## 30. Management

### 30.2.3 Containment

**Figure 30–4—Repeater entity relationship diagram**

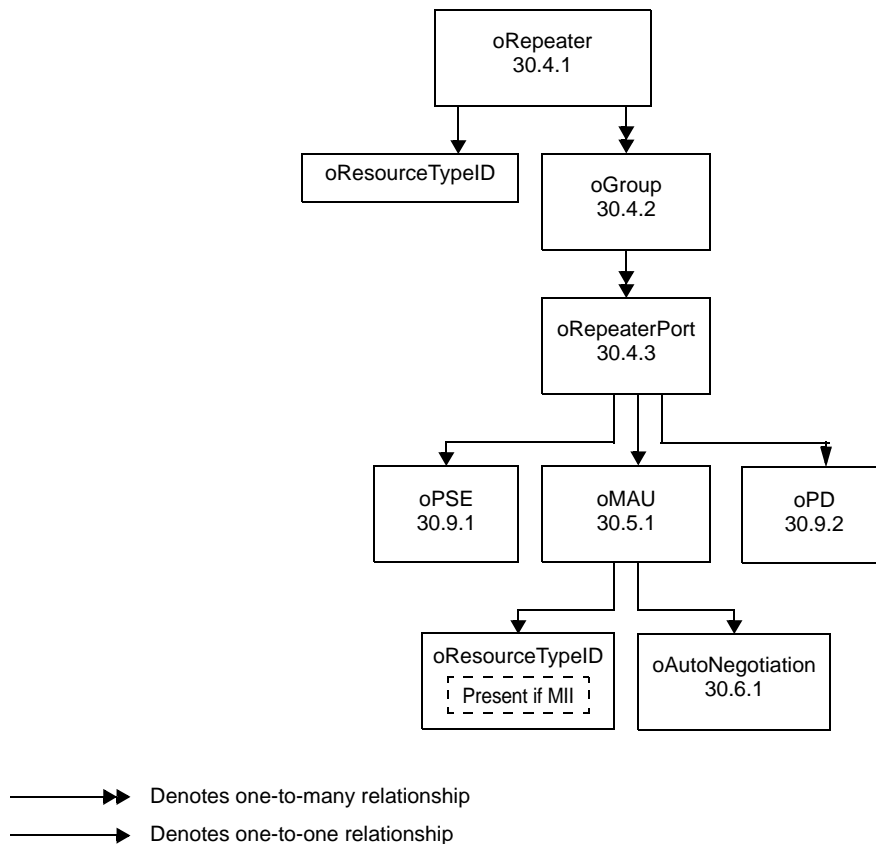
*Replace Figure 30-4 with the following*

**Figure 30–3— DTE System entity relationship diagram**

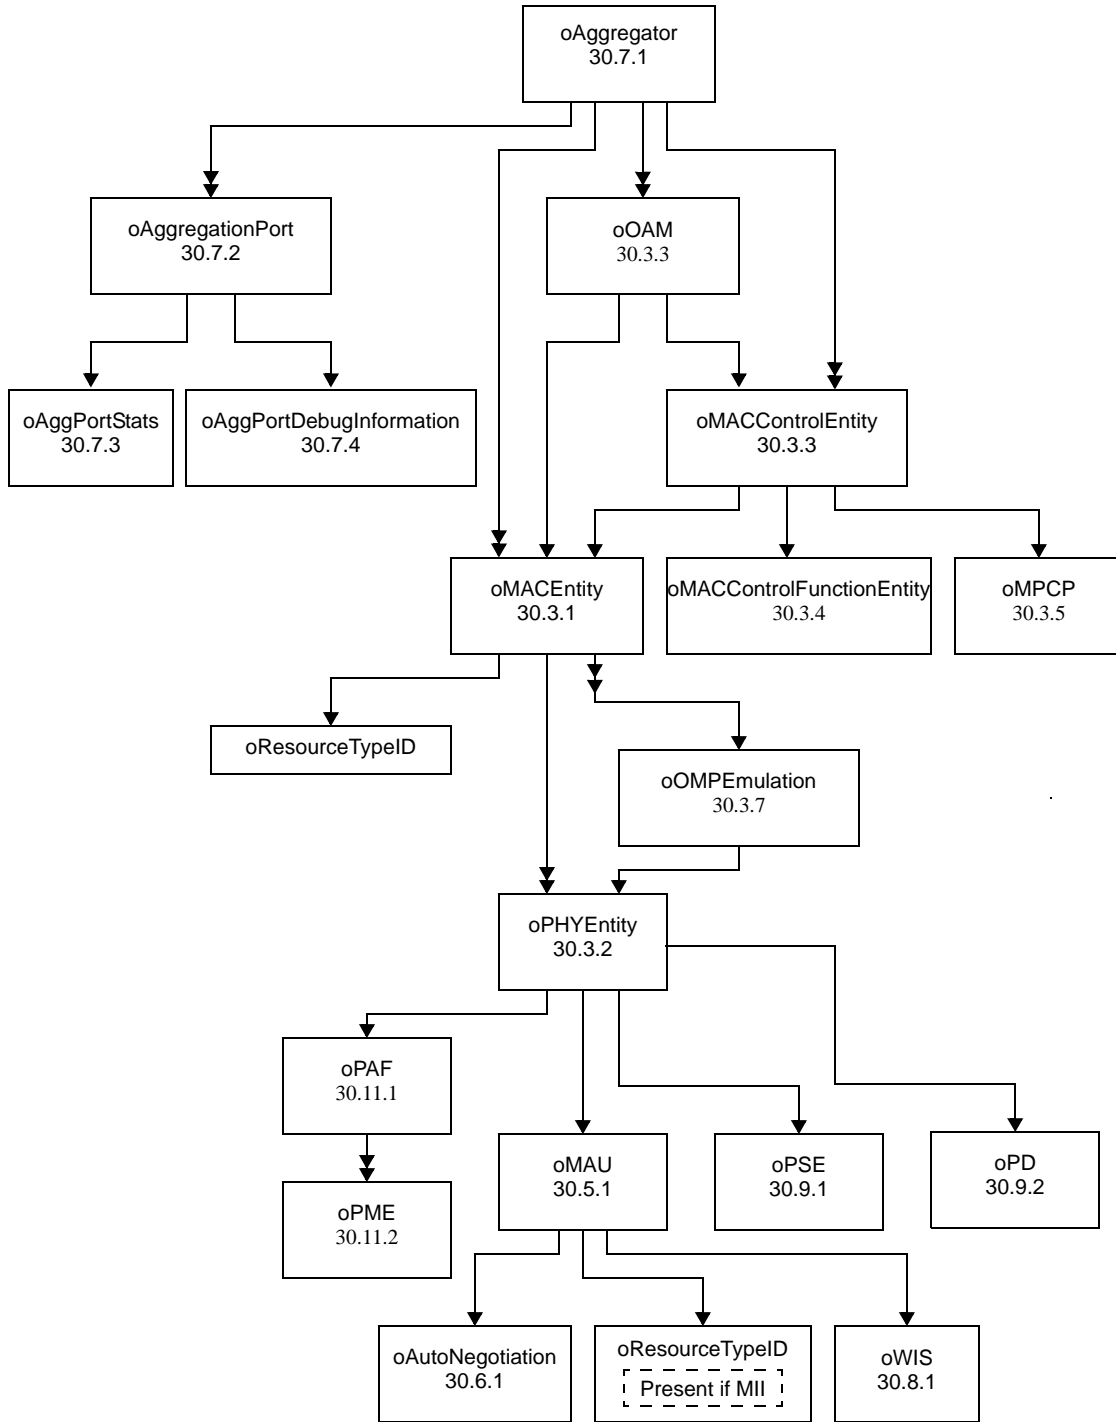
*Replace Figure 30-3 with the following:*

Note—The objects oAggregator, oAggregationPort, oAggPortStats and oAggPortDebugInformation are deprecated by IEEE Std 802.1AX-200X.
